From: McConnell, DAVE P <dave.p.mcconnell@lmco.com>
Sent: Thursday, June 01, 2017 12:02 PM
To: Grant Robinson
Subject: S-76D Air Conditioning Flapper Valve P/N

Case Number: C0061825
Customer: Thai Aviation Services Limited
Aircraft S/N: 761063
Aircraft Model: S-76D
ATA: 21
Part Number: 09076D30P008-01
Case Subject: Sta 215 Air Conditioning Flapper Valve Adrift

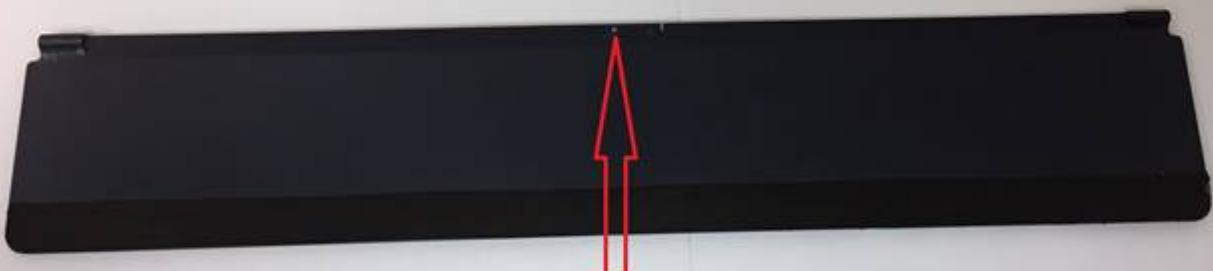
Q1) What is the P/N of this flapper and any detail parts of its installation?

A1) Parts in customer supplied image are 10076B30G102-6 Flap and 10076B30G102-4 Shaft (which is broken in half). Flap and Shaft are part of the 10076B30G011-2 VALVE ASSEMBLY, which is a part of the 09076D30P020-05 AIR DUCT ASSEMBLY installed in aircraft at final assembly.

A2) 98195A050 SPRING, PIN is missing from the hole in the customer supplied image.
